Your Ref: 2311-38006 SRA
Our Ref: F22/31
MSC Ref: MCU/23/0012

**RE: RESPONSE TO SARA INFORMATION REQUEST
APPLICATION FOR A MATERIAL CHANGE OF USE – EDUCATIONAL ESTABLISHMENT
LOT 71 ON SP292140, 267 MCIVER ROAD AND CHEWKO ROAD, MAREEBA.
DEVELOPMENT APPLICATION MCU/23/0012.**

I refer to the State Government's (SARA) Information Request letter dated 16 January, 2024. The following advices, are provided for your information in accordance with the Development Assessment Rules, 2017 supported by the *Planning Act, 2016*.

The Project Manager in conjunction with the Developers have gained LiDAR mapping for the site and provide below for your records. The first image shows the satellite image with the proposed builds and the second image shows the altitude of the property.

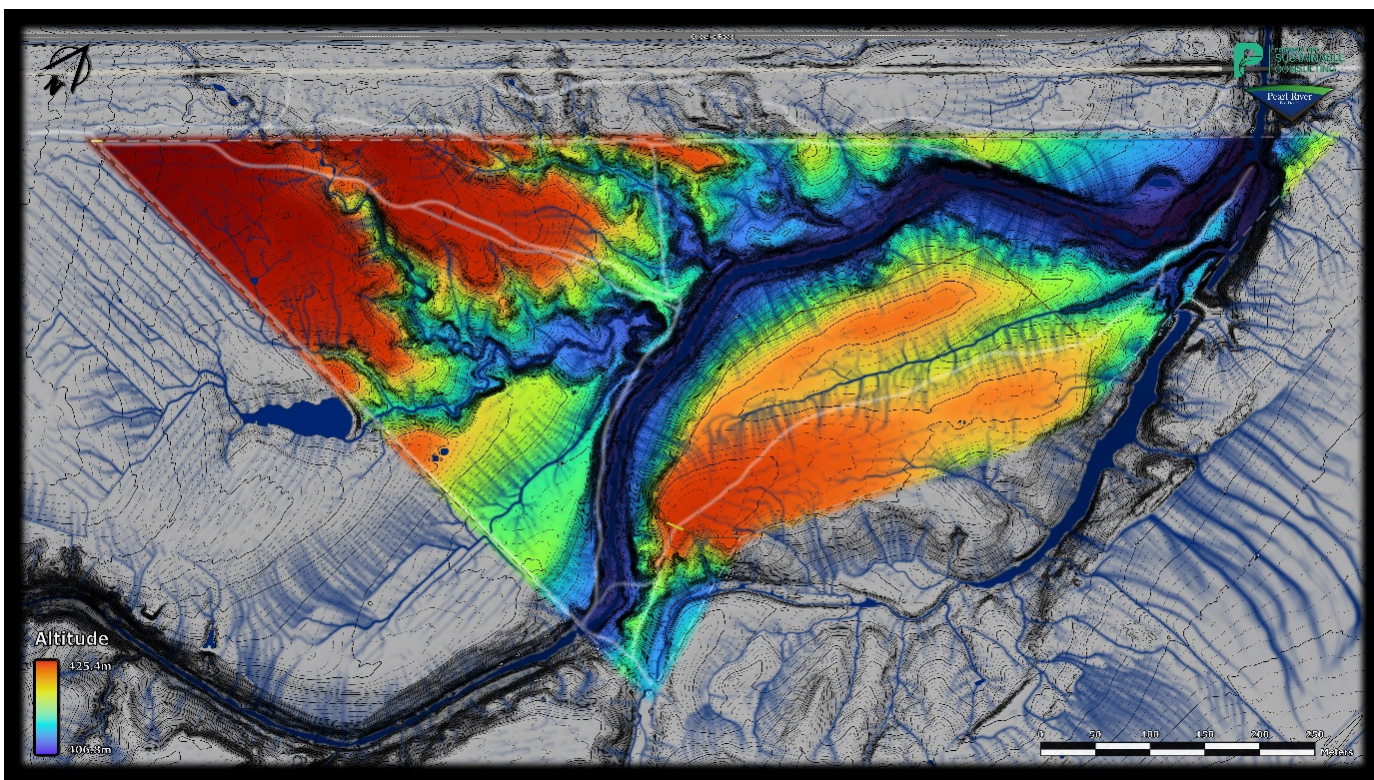
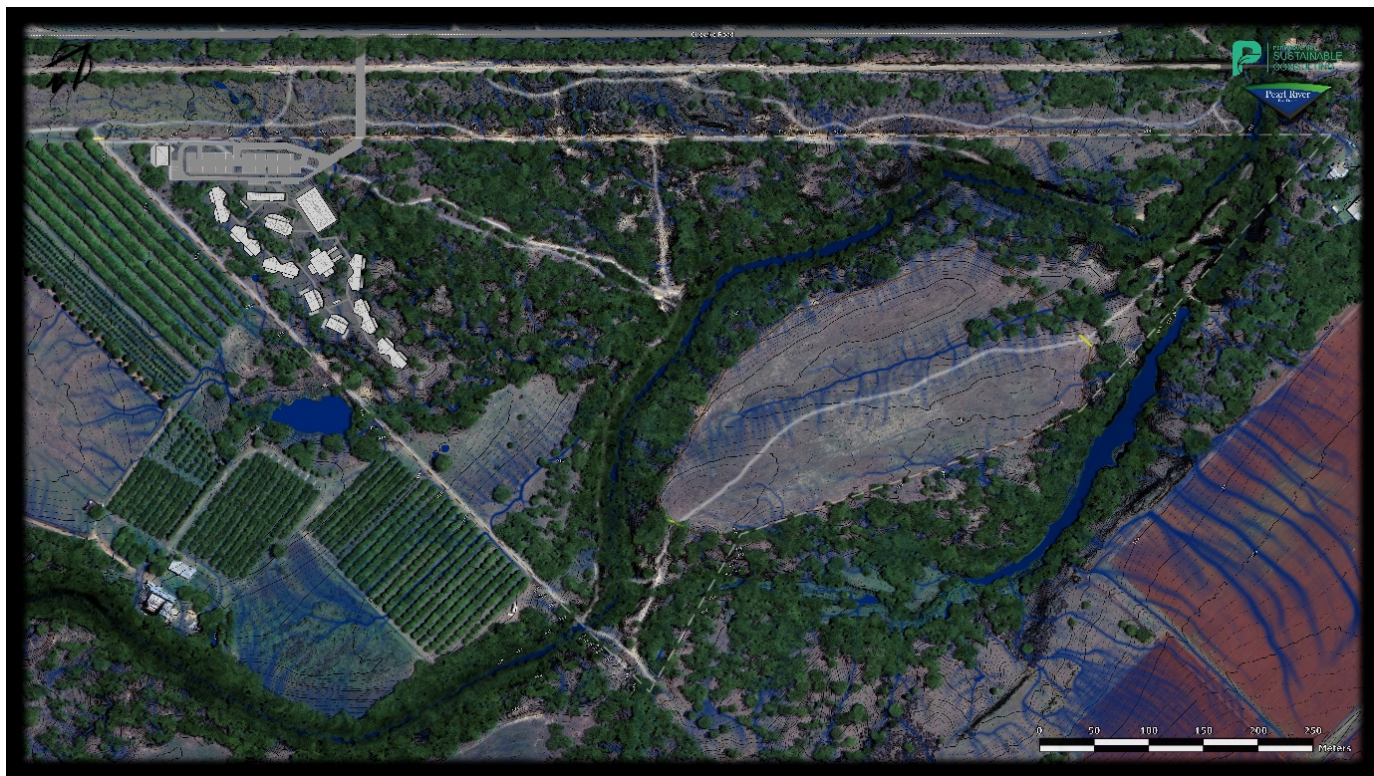
The referral material has not included adequate information to demonstrate that the stormwater impacts of the proposed development will not adversely impact on the railway corridor. In particular, the site appears to both discharge towards the railway corridor and accept stormwater from the railway corridor. The development will increase the impervious area on the site and may therefore alter stormwater impacts in the railway corridor.

The applicant is therefore requested to provide a Stormwater Management Plan to demonstrate compliance with PO12 – PO14 and PO16 of State Code 2: Development in a Railway Environment of the SDAP.

The Stormwater Management Plan should demonstrate that the management of stormwater post development can achieve a no worsening impact (on the pre-development condition) for all flood and stormwater events that exist prior to development and up to a 1% Annual Exceedance Probability (AEP). This should include at least the following flood and stormwater events: 63.2%, 50%, 20%, 10%, 5%, 2% and 1% AEP. Stormwater management for the proposed development must ensure no worsening or actionable nuisance to the railway corridor, including rail transport infrastructure, caused by peak

discharges, flow velocities, water quality, sedimentation and scour effects. In particular, the following should be addressed:

(i) Pre-development condition. Provide information to verify the existing drainage characteristics of the site, particularly in relation to the railway corridor. All legal points of discharge for the development site should be identified.

(ii) Earthworks Plan. Provide a concept earthworks plan, including cross sections/elevations, and any required supporting technical details clearly showing the location and extent of proposed excavation and filling (earthworks). The difference between existing site levels and finished/design levels should be clearly shown.

(iii) Catchment Analysis. Provide pre-development and post-development catchment plans that clearly identify all internal catchments on the site, external catchments draining into the site, the flow paths (direction of flow) within each catchment, the size of each catchment and the legal point of discharge for each catchment.

(iv) Maintain the pre-development condition. The pre-development flow scenario will need to be replicated in the post development condition. The proposed development should not impede or interfere with any drainage, stormwater or

floodwater flows, including sheet flows, from the railway corridor or vice versa. Retaining structures, filling/excavation, landscaping, buildings and structures or any other works to the land should be designed to include provision for

drainage so as not to adversely impact on the railway corridor. The development design will need to address any concentration of flows, potential for back-up/ponding and scour/erosion which may undermine the railway corridor.

(v) Water quantity assessment. The peak discharge analysis should provide adequate details of the pre and post development impervious area of the site and detail analysis of the pre and post development volumes and velocities at

each legal point of discharge. Where mitigation is proposed the design flood peak discharges should be shown for the mitigated case to demonstrate there is no worsening impact on the railway corridor.

(vi) Conceptual drainage layout. Provide a conceptual stormwater drainage layout plan showing the proposed internal stormwater network on the site, including roof-water connections, pit and pipe network, field inlets, any detention basins/tanks, swales/open drains and demonstrate how all roof and surface water flows will be collected and conveyed to the legal points of discharge.

Mitigation measures. include details of the mitigation measures proposed to address any potential stormwater and flooding impacts of the proposed development. All mitigation measures must be located on the site and not in the railway corridor.

These images show us the Pre-construction state of the property that;

1. The proposed construction is contained on the highest part of the property based on the below LiDAR Maps.
2. The natural levels of the land are highest where the development is proposed and have fall towards the creek.

During the Design Development phase of the project a RPEQ Civil Engineer will be engaged for;

1. An assessment of the geotechnical investigation information
2. Design of all proposed building pads and trafficable surfaces
3. Assessment of all stormwater and direction of stormwater discharge to existing creek.

We acknowledge your concern regarding the Stormwater Impact on the Railway Corridor, during design development all stormwater will be considered, designed and directed to ensure that there is no impact on your

infrastructure. It is not considered that there will be any significant additional Stormwater Impacts to the Railway Corridor with the proposal. The Lidar Imagery clearly demonstrates that natural flows, features, and drainage over the property which is directed away from the Railway Corridor.
